ALERT SERVICE BULLETIN
REVISION NOTICE

SUBJECT: REVISION "A" TO ALERT SERVICE BULLETIN 407-10-92 (TAIL ROTOR BLADES 406-016-100-119 AND 407-016-001-101, INSPECTION OF)

NO. 407-10-92

SUBJECT: TAIL ROTOR BLADES 406-016-100-119 AND 407-016-001-101, INSPECTION OF | A

Figure 1. Areas for particular attention during inspection

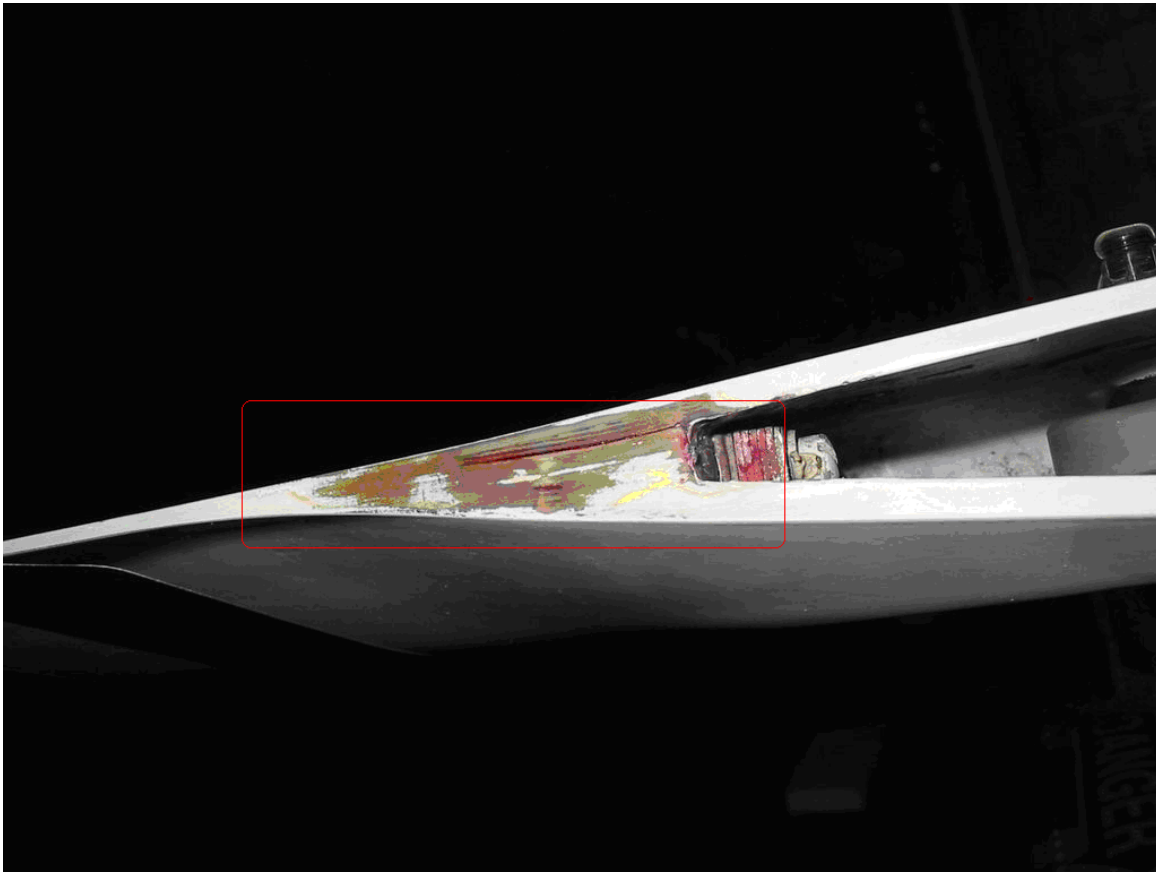
Pilots should be advised to pay particular attention to the area shown in Figure 1, when performing their pre-flight check.

1. Refer to Figure 1. Use detergent (C-318) and thoroughly clean the tail rotor blade in the area to be inspected.
2. Inspect tail rotor blade(s) for evidence of separation between skin plies and root end block at trailing edge using a 10x magnifying glass.

- If cracks are found, remove tail rotor blade from the aircraft and proceed with PART II of this bulletin.
 - If no crack is found but the tail rotor assembly has history of balance change or balance difficulties for unknown reason, remove tail rotor blade from the aircraft and proceed with PART II of this bulletin.
 - If no crack is found and the tail rotor assembly has no history of balance change or balance difficulties, blade may be returned to service.
3. Make an entry in the tail rotor blade historical record to reflect compliance with PART I of this bulletin.
 4. Refer to the BHT-407-MM, Chapter 5 for dynamic balance requirements of the tail rotor hub and blade requirement.

Figure 2 Areas to verify during leak check

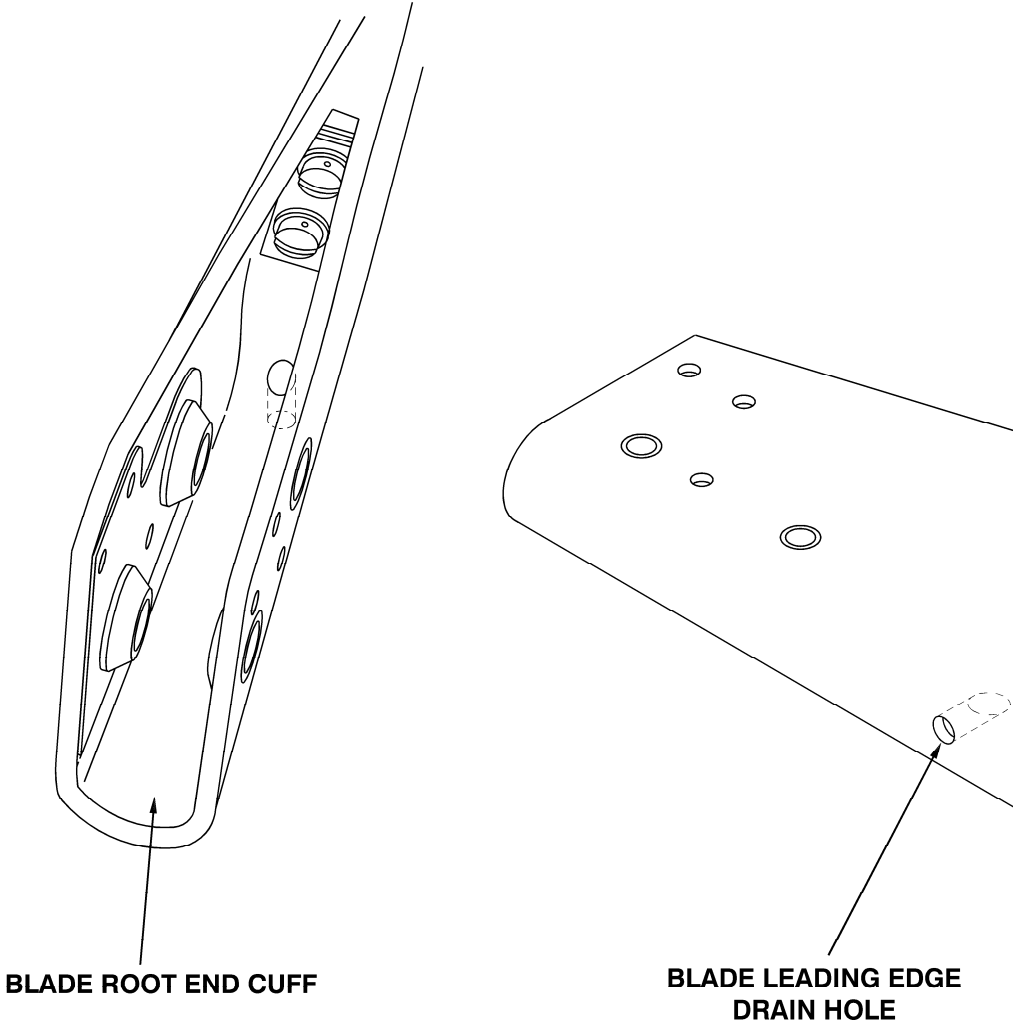
6. With the blade under water, check for air leaks that will be indicated by a steady stream of fine bubbles originating from a single point.
7. Gently rotate blade back and forth to allow a thorough inspection of all the blade surfaces. Refer to the Figure 2, pay particular attention to the root end cuff and around the leading edge drain hole.

Figure 3 Water tightness check.

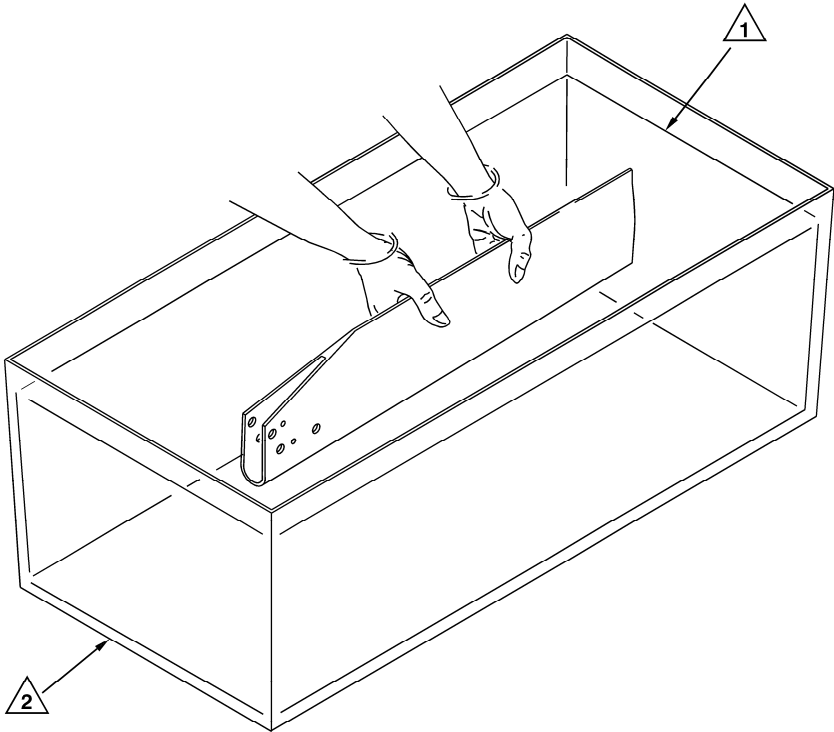
- 1** Water temperature to be maintained between 60°C to 80°C (140°F to 175°F).
- 2** Water tank should be 18 inches wide x 36 inches long by 18 inches deep or equivalent.
